PROPOSED MIXED-USE DEVELOPMENT, WHALLEY TRANSPORT ASSESSMENT ADDENDUM NOTE REV A

VN91274 – TA Addendum Note Rev A

4. Comments (dated 7th January 2020) on the TA were provided by Lancashire County Council (LCC) Highways Development Control Officer, Neil Stevens, and these are provided at **Appendix A** to this Note. Subsequently, Vectos met with Neil Stevens on the 19th February 2020 at the RVBC offices in Clitheroe to discuss the comments, and further dialogue has taken place over the course of 2020, with further information provided to LCC Highways through a TA Addendum Note in July, to which comments were provided by LCC Highways in October 2020. This revised TA Addendum Note therefore responds to all the comments received from LCC Highways to date.

DRAWING TITLE:
**Proposed Arrangement
 Along Clitheroe Road
 (Footway Links)**

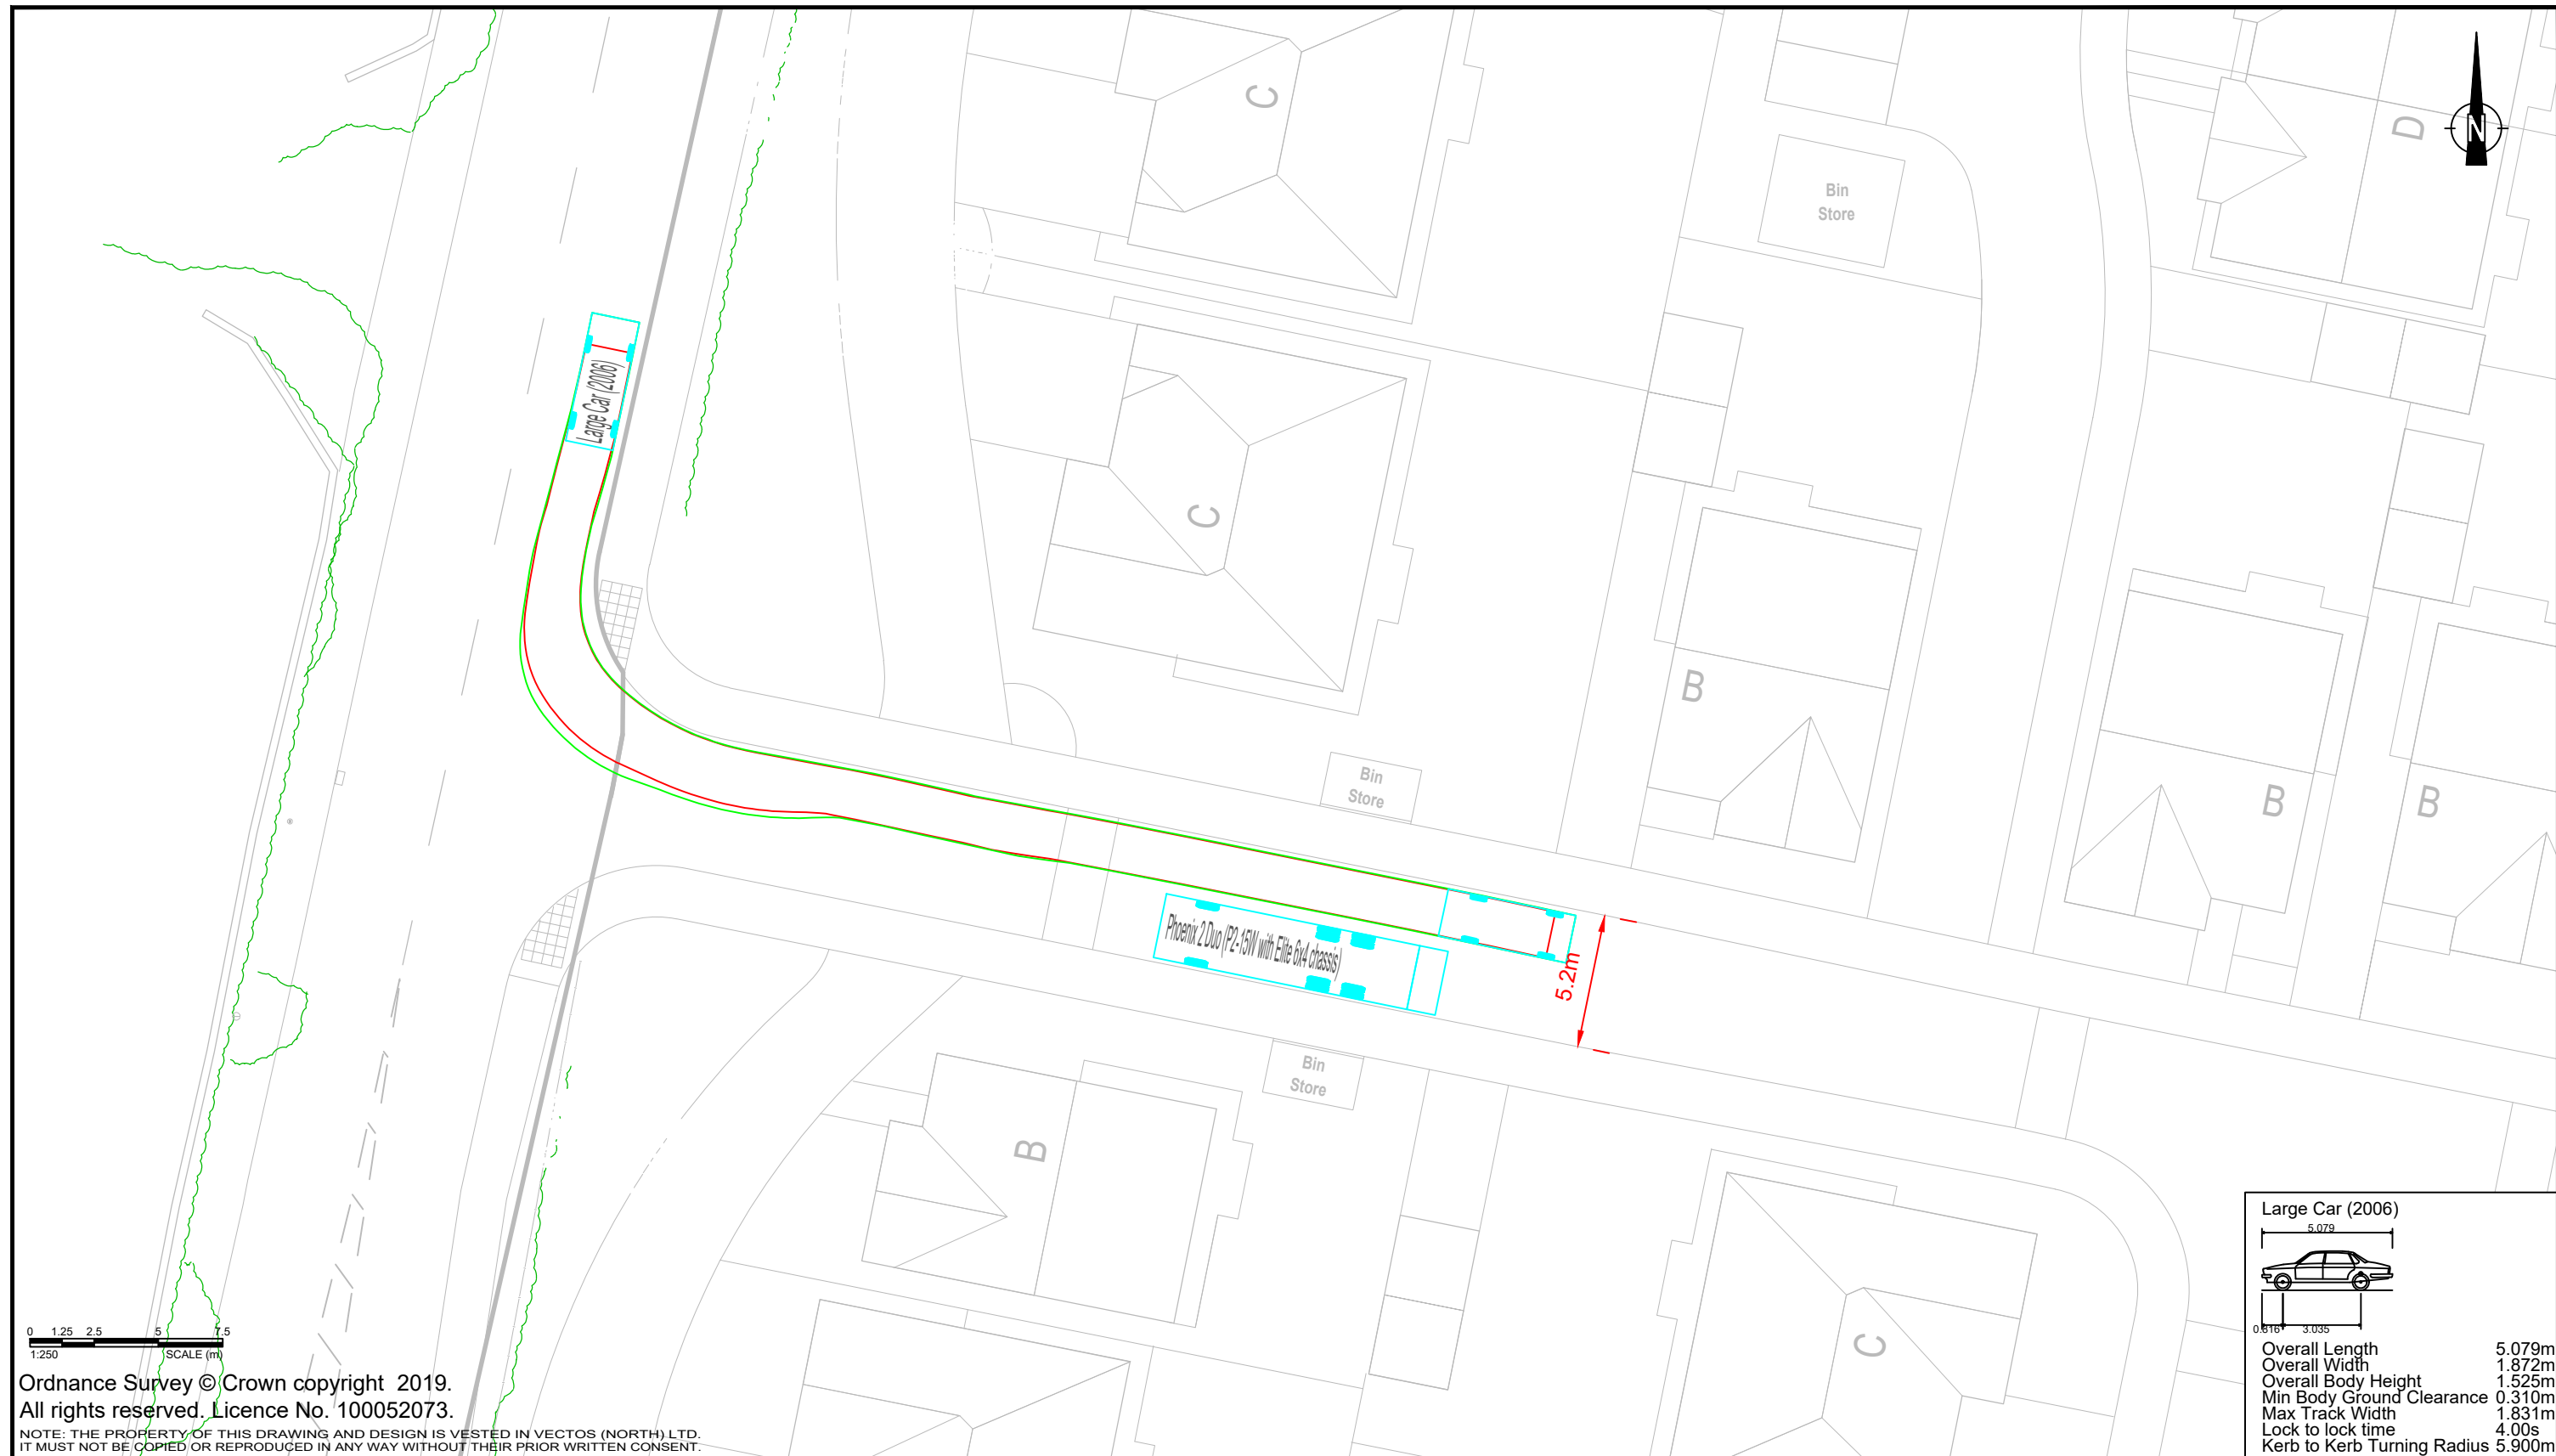
I have no concerns with the access location and that visibility can be achieved. However the plans do not indicate the extend of new cycle/footway on Whalley Rd/Clitheroe Rd. the foot/cycleway detail as presented at Lamb Roe Gardens is misleading (no foot/cycle way currently exists. Notwithstanding these anomalies, once the extent is agreed, safe crossing provision over Whalley Rd/Clitheroe Rd will be required to support movements from the site to the south as well as dropped crossings at Lamb Roe Gardens. In addition consideration to need to be given to overcome visibility issues between ped/cyclists and motorists from Lamb Roe Gardens.

19. This proposed access has been amended to reflect discussions with LCC Highways, with the changes shown in **Vectos Drawing VN91274-D101 B** and **VN91274-D102 B** and summarised as follows:
- Internal side roads relocated to be further from Clitheroe Road.
 - Proposed footway along Clitheroe Road shown.
 - Pedestrian refuge crossing on Clitheroe Road added to assist pedestrian movement between the site and Whalley to the south.
 - Bin stores relocated further into the site and main access road widened to better accommodate passing manoeuvre of a refuse vehicle and car (see **Vectos Drawing VN91274-TR103 A** for swept path analysis).

Swept Path Analysis - Large Car

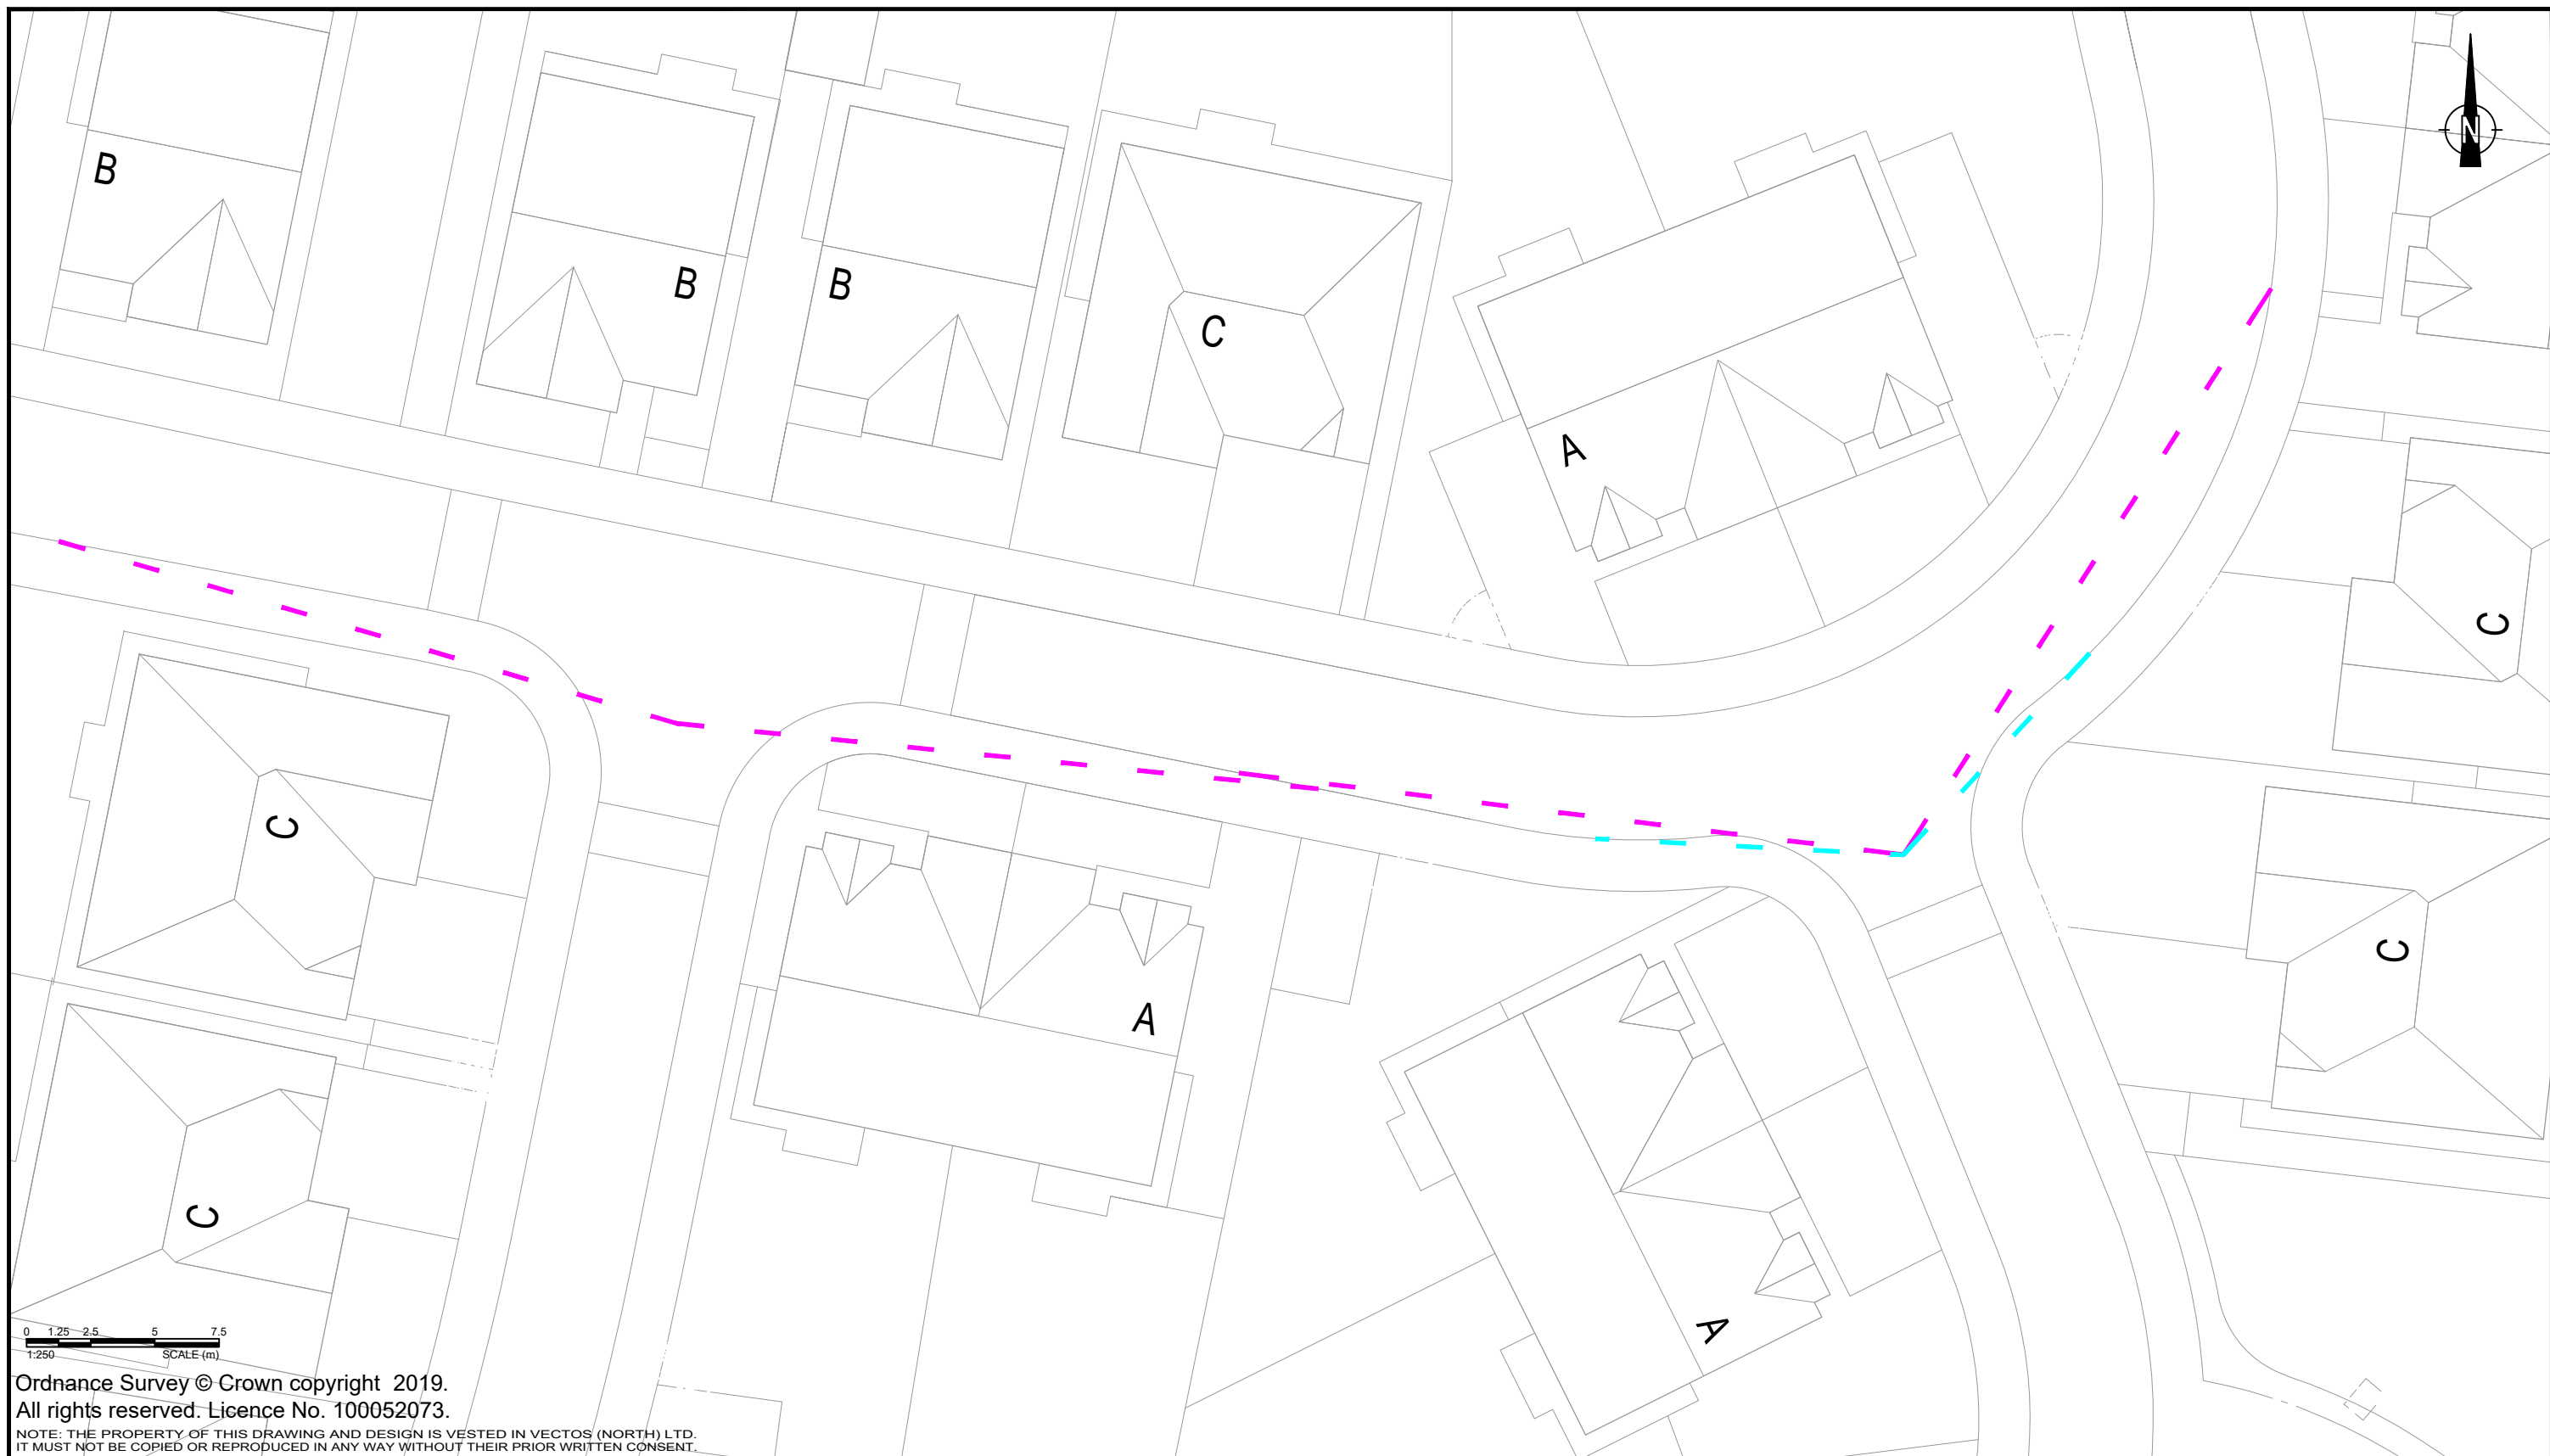
As highlighted within the plans the 2 side roads onto the spine road are approximately 7m away from the site junction. This could result in vehicles waiting within the junction mouth as a vehicle exits, in addition also promotes poor use of the highway for certain

movements. Proposed trees could also hinder visibility. This layout is not suitable for waste collection. This detail is not acceptable.

With regard to road widths again as highlighted in para 3.2 I have concerns with the internal road widths as proposed to support a large car and a service vehicle including wing mirrors and also having regard to the bend within the spine road. A number of details will require to be modified before the layout can be considered suitable.
